City of Portland Design Commission

Design Advice Request

SUMMARY MEMO

Date: 10/22/2024
To: Garrett Helm | Bora Architecture & Interiors
From: Tanya Paglia, Design & Historic Review Team
503-865-6518 | Tanya.Paglia@portandoregon.gov
Re: EA 24-067517 – Ida B. Wells Modernization
Design Advice Request Commission Summary Memo – September 19, 2024

Proposed Site Plan

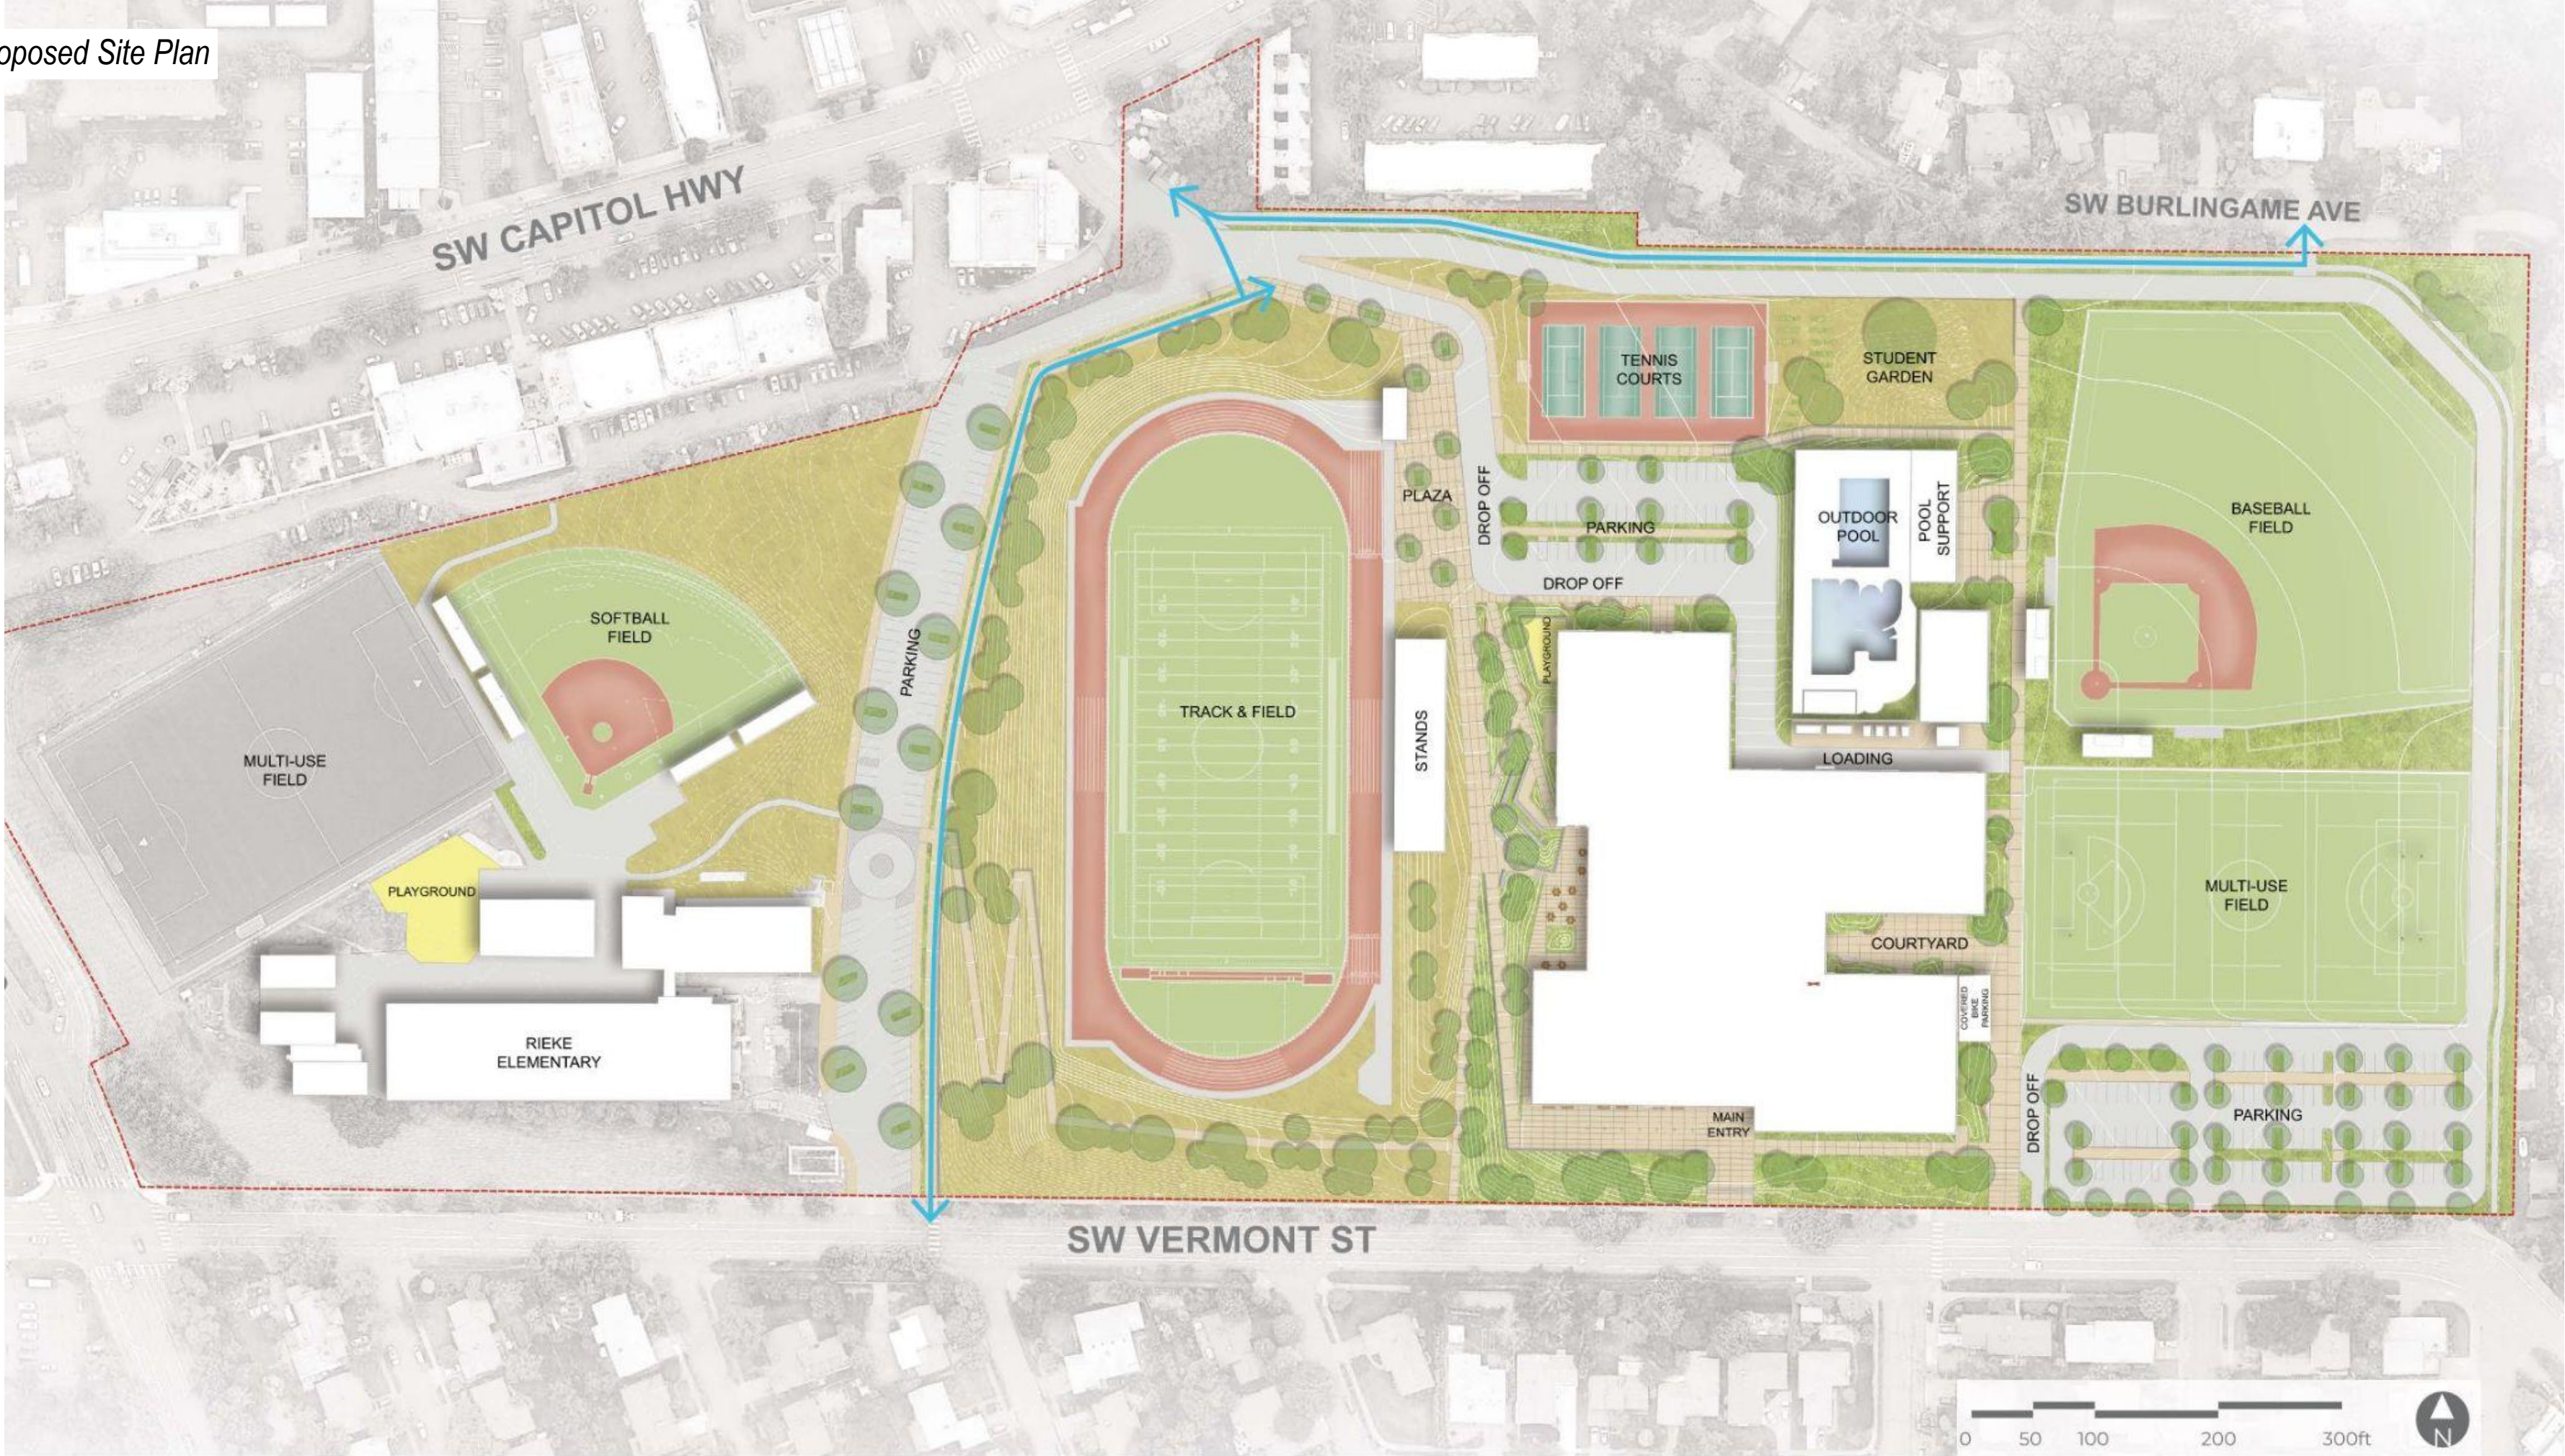
- General support for the project as an improvement to the school campus experience.
- Rework the north campus approach to create a sense of place and safely channel pedestrians and cyclists to the main building entrance at the south side of the site via the north-south pedestrian connection.

- A prominent arrival plaza on the north end of the site will create a more visible and welcoming entry sequence for the campus.
- The building massing and placement are on track.

- Support for locating grandstand on the west side of the track and field.
- Reconfigure the pool parking lot driveway to improve bike/ped safety at the north end of campus and to avoid breaking up the north-south pedestrian plaza/walkway.

- Prioritize bicycle lanes and crossings for cyclists entering campus from the north and improve all shared bike/ped facilities throughout the campus with clear delineations of which is bike vs ped via material changes, and adequately size paths for all users.
